CALVERT CLIFFS NUCLEAR POWER PLANT, UNIT 1

AMENDMENT TO FACILITY OPERATING LICENSE

Amendment No. 151  
License No. DPR-53

Attachment:  
Changes to the Technical  
Specifications

TIME IN CYCLE  
Figure 3.1-1b

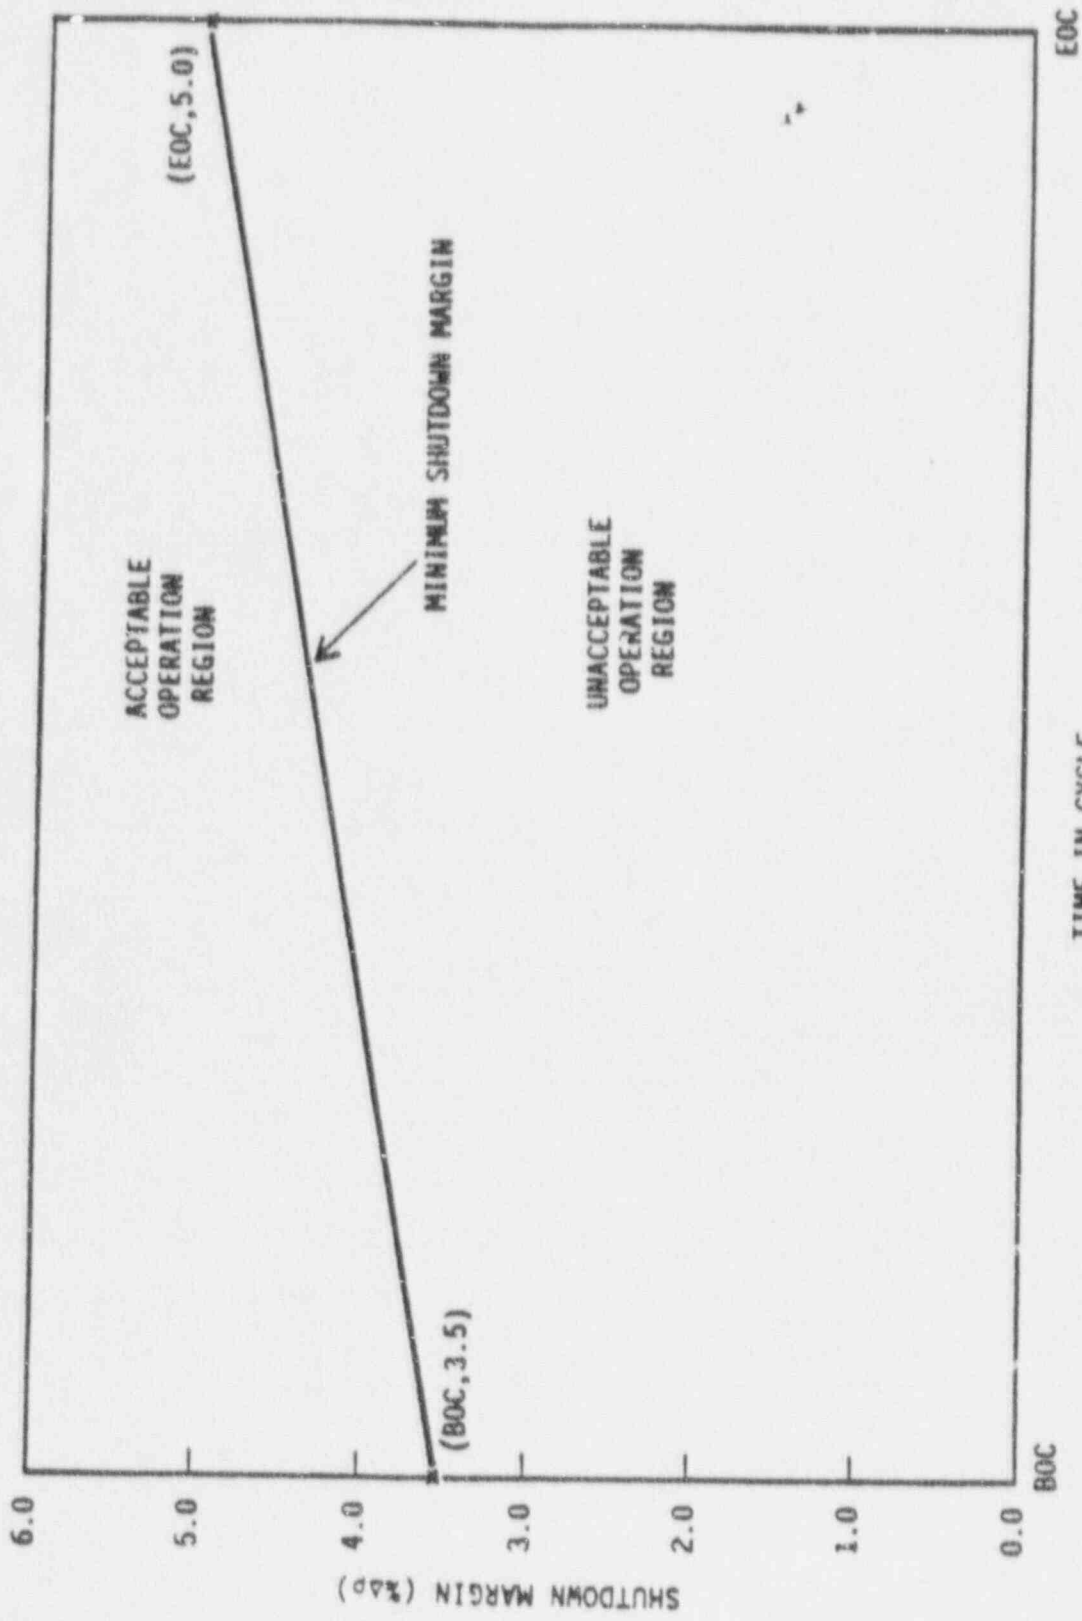
3.1.1.1 The SHUTDOWN MARGIN shall be equal to or greater than the limit line of Figure 3.1-1b.

With the SHUTDOWN MARGIN less than the limit line of Figure 3.1-1b immediately initiate and continue boration at  $\geq 40$  gpm of 2300 ppm boric acid solution or equivalent until the required SHUTDOWN MARGIN is restored.

4.1.1.1.1 The SHUTDOWN MARGIN shall be determined to be equal to or greater than the limit of Figure 3.1-1b:
